HISTORIC AND DESIGN REVIEW COMMISSION

August 15, 2018

HDRC CASE NO: 2018-381
ADDRESS: 121 SAN ARTURO
LEGAL DESCRIPTION: NCB 923 BLK 1 LOT SE 74.2 FT OF 5
ZONING: RM-4, H
CITY COUNCIL DIST.: 1
DISTRICT: Lavaca Historic District
APPLICANT: Salvador Flores
OWNER: Salvador Flores
TYPE OF WORK: Fencing; remove chimney
APPLICATION RECEIVED: July 18, 2018
60-DAY REVIEW: September 17, 2018
REQUEST:

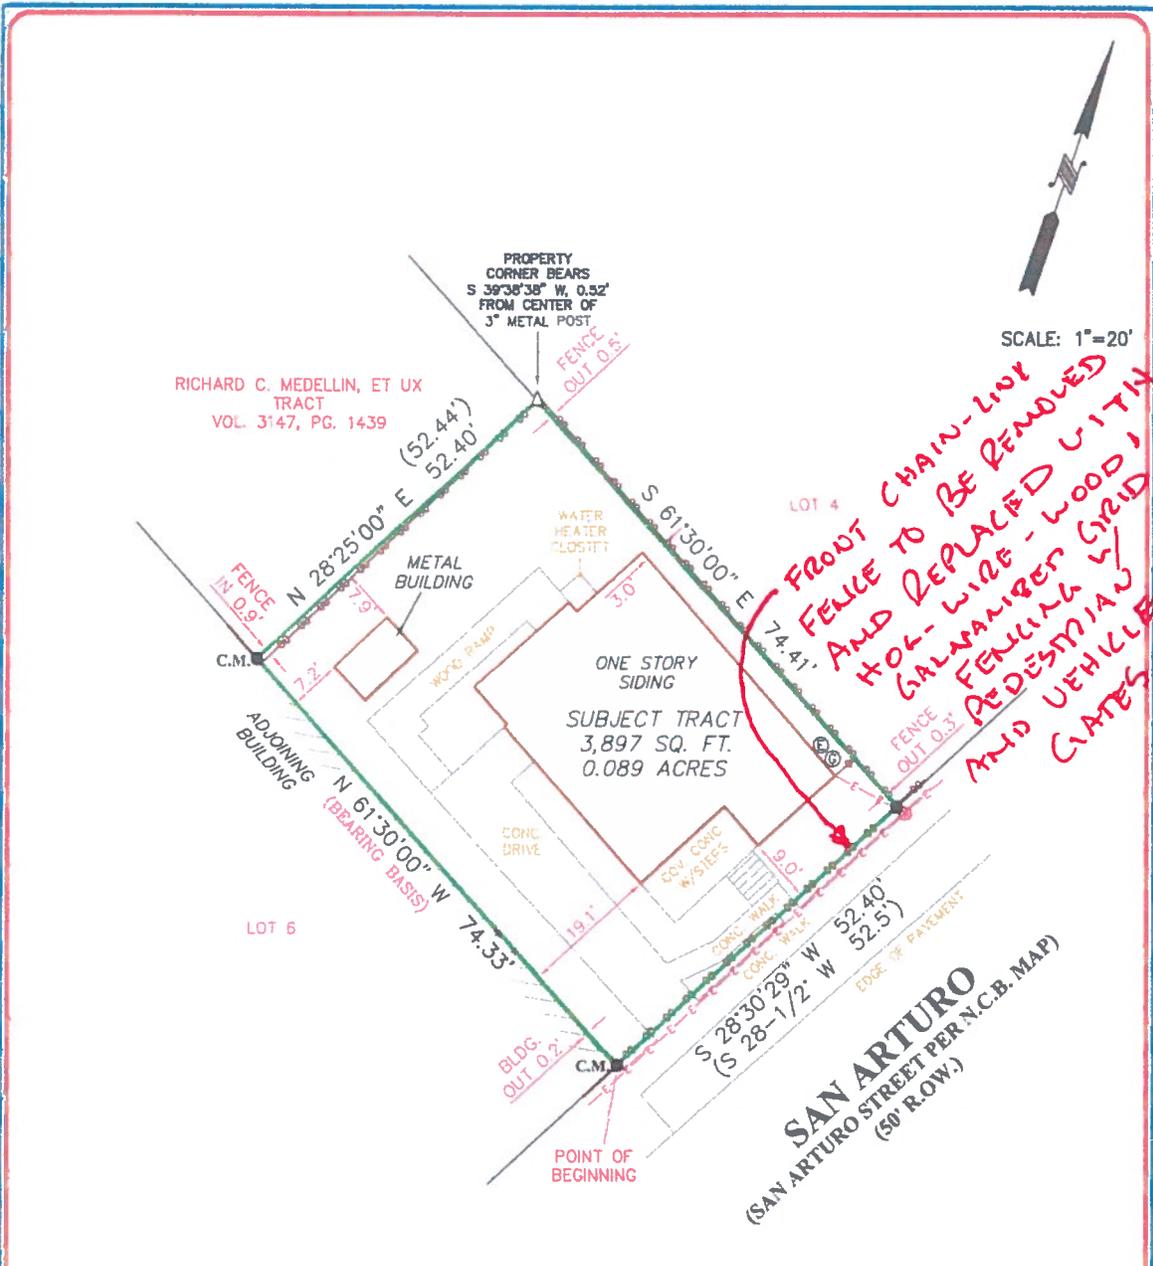
- c. FENCE LOCATION – The applicant is requesting to install a fence spanning across the front yard including a driveway gate. The proposed fence line will meet the corning of the commercial structure at 636-644 S Presa and neighboring chain link fence at 117 San Arturo. According to the Guidelines for Site Elements 2.B.ii, new front yard fences should not be introduced within historic districts that did not historically. Staff finds that fences are

found on San Arturo and in the Lavaca Historic District. Staff finds the proposed location and configuration of the new fence appropriate.

- d. **FENCE DESIGN** – The applicant is requesting to install front yard fencing that features 4ft tall cattle panel fence with wood framing and metal wire. According to the Guidelines for Site Elements 2.B.i., the design of the fence should respond to the design and materials of the primary historic structure or structures of a similar style in the neighborhood in relation to scale, transparency, and character. Cattle panel fencing is found at 202 San Arturo and within the Lavaca Historic District. Staff finds the proposed design and height of the fence appropriate.

- i. Staff does not recommend that removal the chimney. Staff recommends that the chimney be reconstructed to match the profile of the original.
- ii. Staff recommends of approval of the front yard fence with the stipulation that no portion exceeds four feet in height.
